Contract No. T201504401.01
Federal Aid Project No. ESTP-N011(31)
Elkton Road, MD Line to Casho Mill Road
New Castle County

Enclosed is Addendum No. 2 for the referenced contract consisting of the following:

1. The Bid Proposal Cover, revised, to be substituted for the same page of the Proposal.
2. The following plan sheets have been revised: 3, 7, 8, 9, 10, 11, 12, 13, 14, 15, 16, 17, 18, and 141.

TS-09

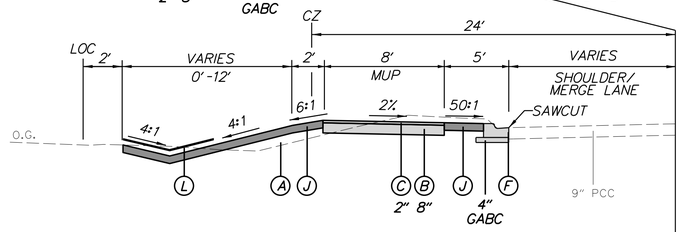
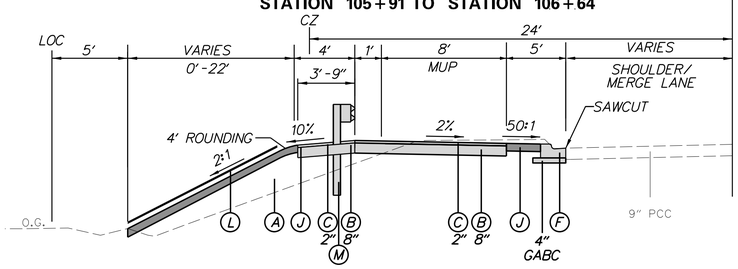
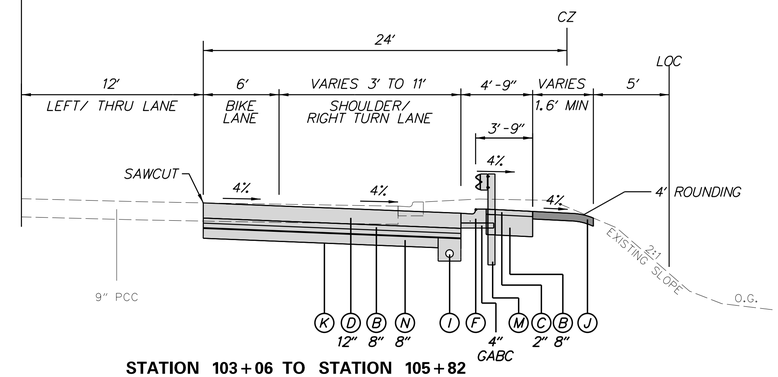
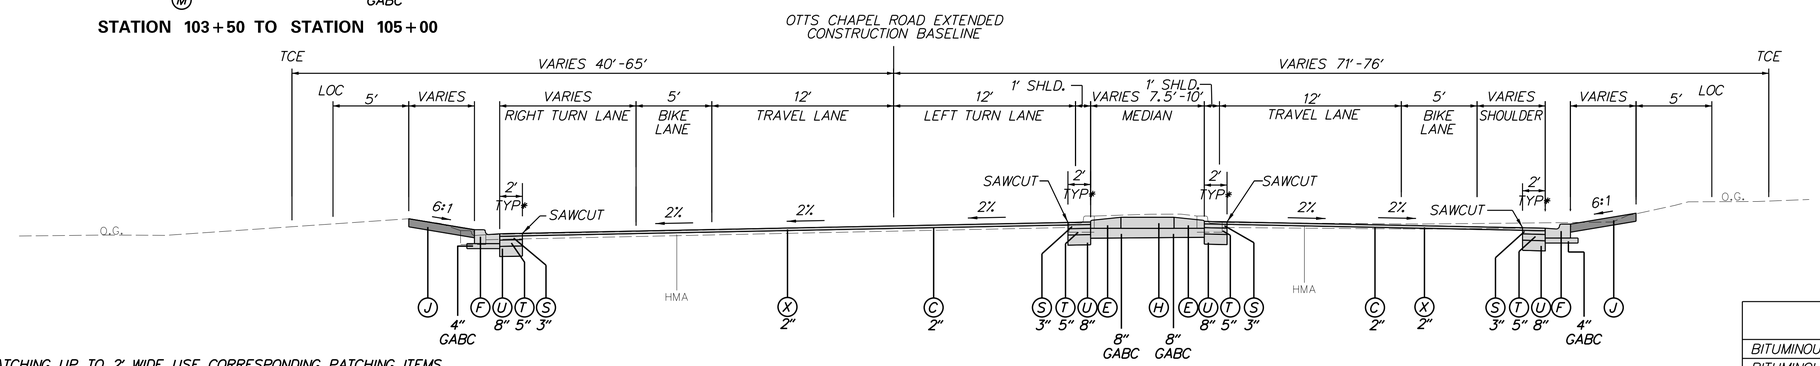
1. ~~CONCRETE PAVEMENT ON ELKTON ROAD SHALL BE 12 1/4" TO ACCOUNT FOR GRINDING~~
2. USE EROSION CONTROL BLANKET MULCH FOR ENTIRE 2:1 SLOPES OR STEEPER.

ADDENDA / REVISIONS		
1	REPLACED PAGES 1 THRU 432	11-15-2019 (LB)
2	REMOVED NOTE #1	12-09-2019 (LB)

TS-10

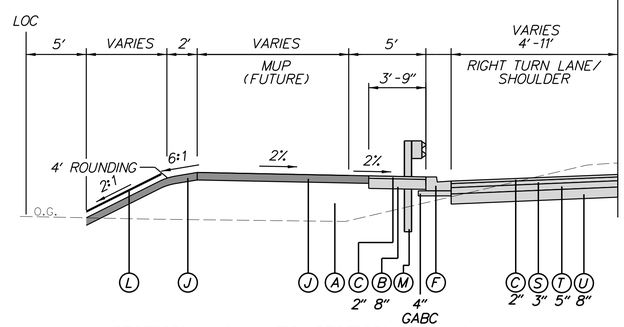
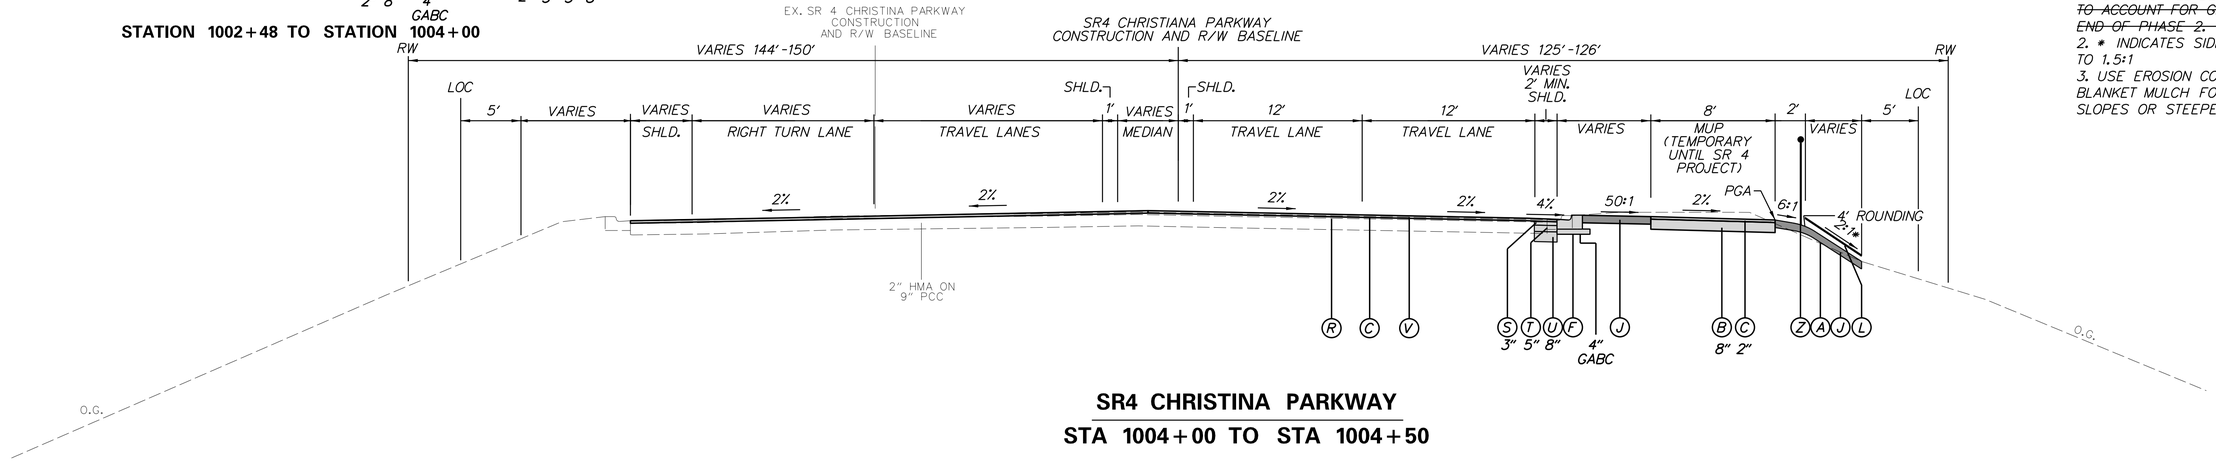
2. ~~1. CONCRETE PAVEMENT ON ELKTON ROAD ND SHALL BE 12 1/4" TO ACCOUNT FOR GRINDING AT THE END OF PHASE 2.~~
2. * INDICATES SIDE SLOPE VARIES TO 1.5:1
3. USE EROSION CONTROL BLANKET MULCH FOR ENTIRE 2:1 SLOPES OR STEEPER.

1	REPLACED PAGES 1 THRU 432	11-15-2019 (LB)
2	REMOVED NOTE #1	12-09-2019 (LB)

TS-11

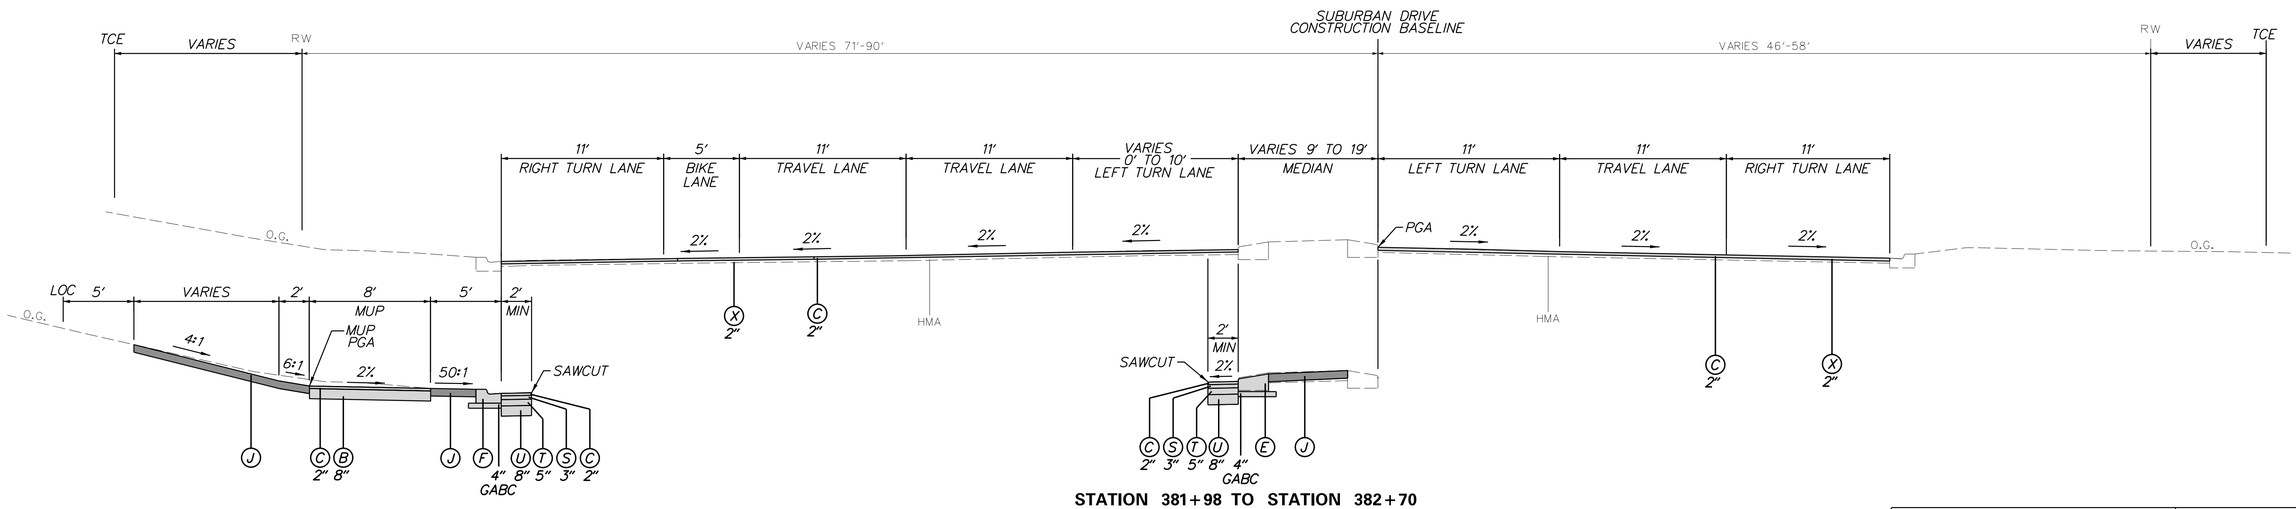
2. ~~CONCRETE PAVEMENT ON ELKTON ROAD NB SHALL BE 12 ¼" TO ACCOUNT FOR GRINDING AT THE END OF PHASE 2.~~

SHEET NO. 18

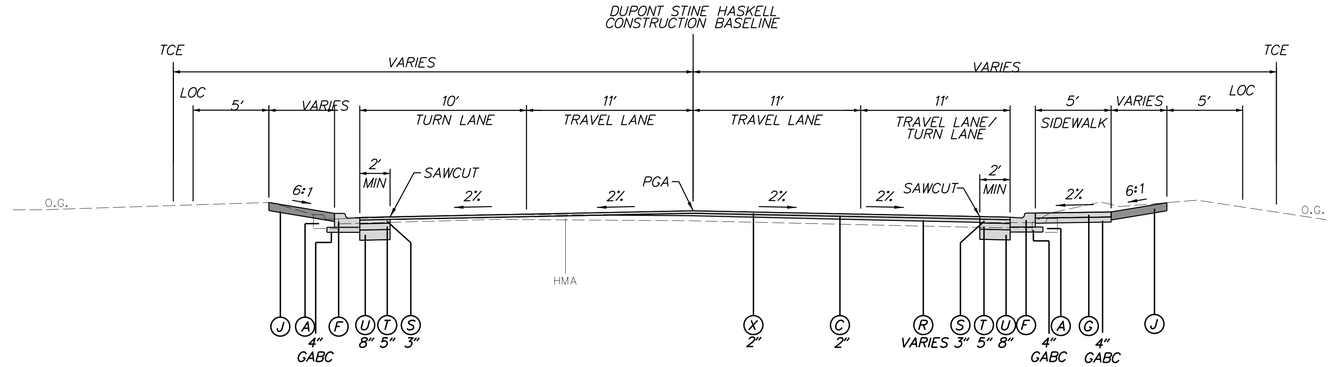
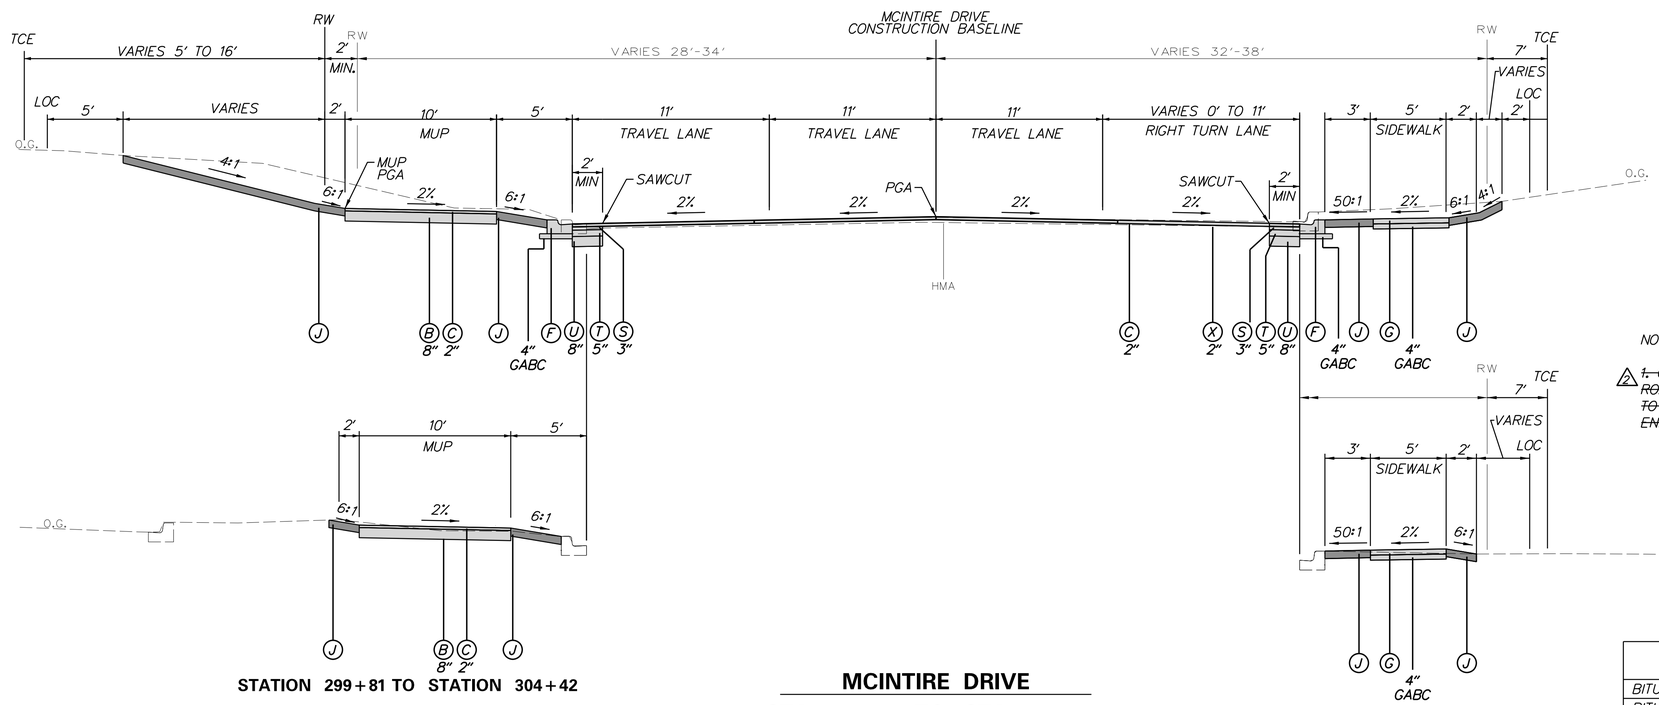
1. ~~CONCRETE PAVEMENT ON ELKTON ROAD NB SHALL BE 12 1/4″ TO ACCOUNT FOR GRINDING AT THE END OF PHASE 2.~~

CONCRETE JOINT BETWEEN P.C.C. CURB AND PRECAST CONCRETE PAVEMENT PANELS

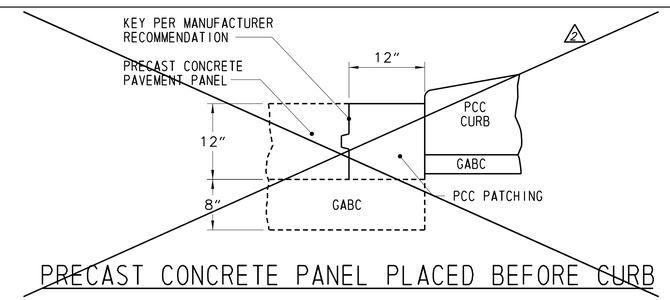
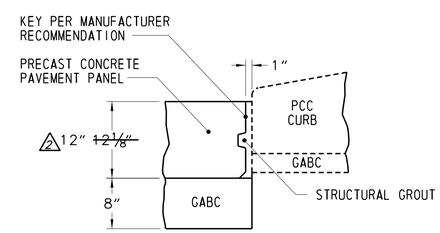
~~PRECAST CONCRETE PANEL PLACED BEFORE CURB~~

2 ~~PRECAST CONCRETE PANEL PLACED AFTER CURB~~

ADDENDA / REVISIONS		
1 REPLACED PAGES 1 THRU 432	11-15-2019 (LB)	
2 REVISED JOINT DETAIL	12-09-2019 (LB)
